# UNITED STATES PATENT AND TRADEMARK OFFICE

10/589,350

Tomohisa Hoshino

<b>Office Action Summary</b>	<b>Application No.</b> 10/589,350	<b>Applicant(s)</b> HOSHINO, TOMOHISA	
	<b>Examiner</b> DAVID M. SINCLAIR	<b>Art Unit</b> 2831

Figure 1: Altered version of Ryhanen '724 fig. 13a showing examiner labels

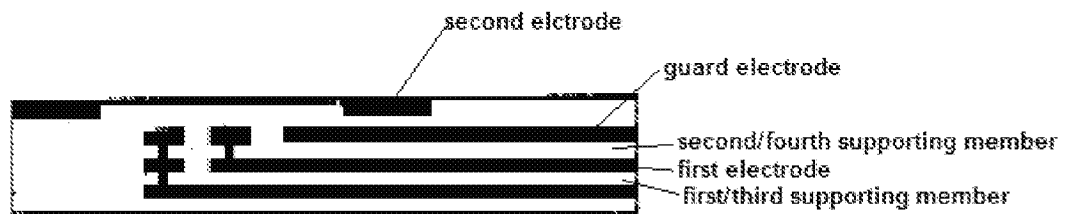
The capacity type sensor according to claim 1 further comprising a first supporting member to fix said guard electrode and said first electrode (present office action fig. 1 (POA1)).

The capacity type sensor according to claim 1 further comprising a second supporting member to fix said second electrode and said guard electrode

(POA1).

A capacity type sensor comprising: a first electrode with wider area (s - fig. 13; [0069]); a second electrode with narrower area (D – fig. 13; [0069]) which is disposed on said first electrode with the wider area; a third supporting member which is formed on said first electrode with the wider area; and a fourth supporting member which is supported by said third supporting member, wherein said second electrode with the narrower area is formed on said fourth supporting member (present office action fig. 1 (POA1)).

The capacity type sensor according to claim 18 further comprising: a guard electrode (g – fig. 13; [0069]) which is disposed between said third supporting member and said fourth supporting member (POA1); a potential equalizer to make the potential difference between said first electrode and said guard electrode close to zero ([0068]); and a capacity type sensor detector to detect

Figure 2: Altered version of Ackland '195 showing dielectric layers and examiner labels

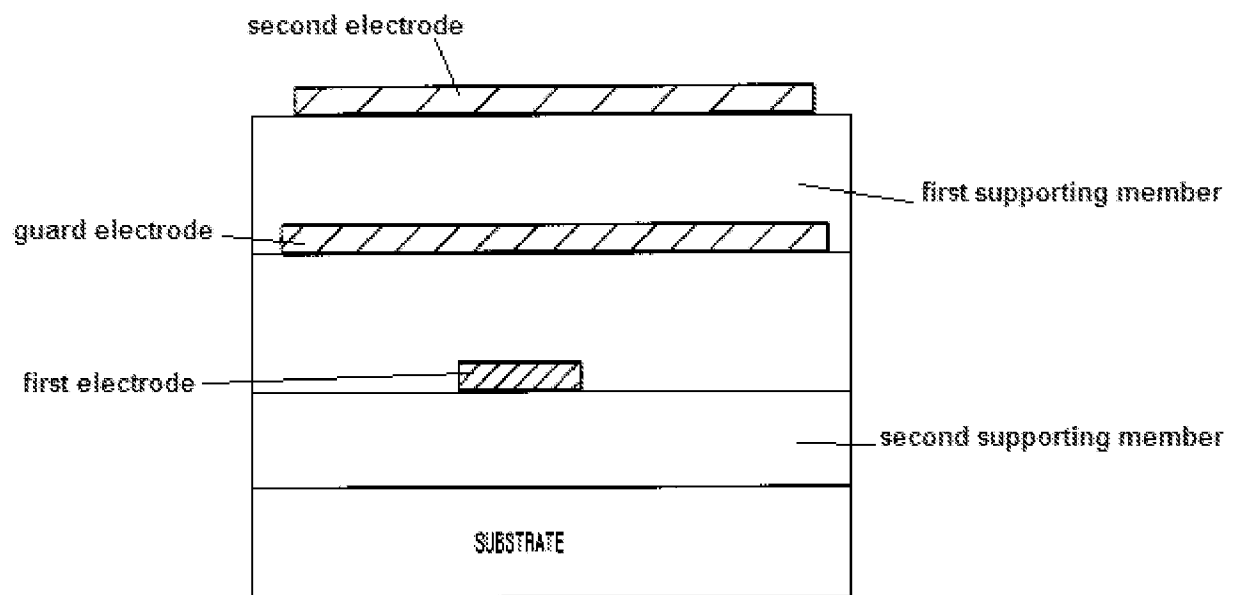
A capacity type sensor comprising: a first electrode (44 – fig. 3b; C4:L63) and a second electrode (48 – fig. 3b; C5:L20-21) which are oppositely disposed each other and an area of either one of said first and second electrode is made narrower than another (fig. 3b); and a first supporting member (preset office action fig. 2 (POA2) & C3:L45-51) which is disposed outside of outer periphery of one of said electrodes with a narrower area to support another one of said electrodes with a wider area.

The capacity type sensor according to claim 10 further comprising a substrate, wherein said supporting member supports said electrode with the wider area on said substrate (POA2).

The capacity type sensor according to claim 11, wherein either one of said first or second electrodes is disposed on said substrate, and a second supporting member is disposed between said substrate either one of said electrodes which is disposed on said substrate (POA2).
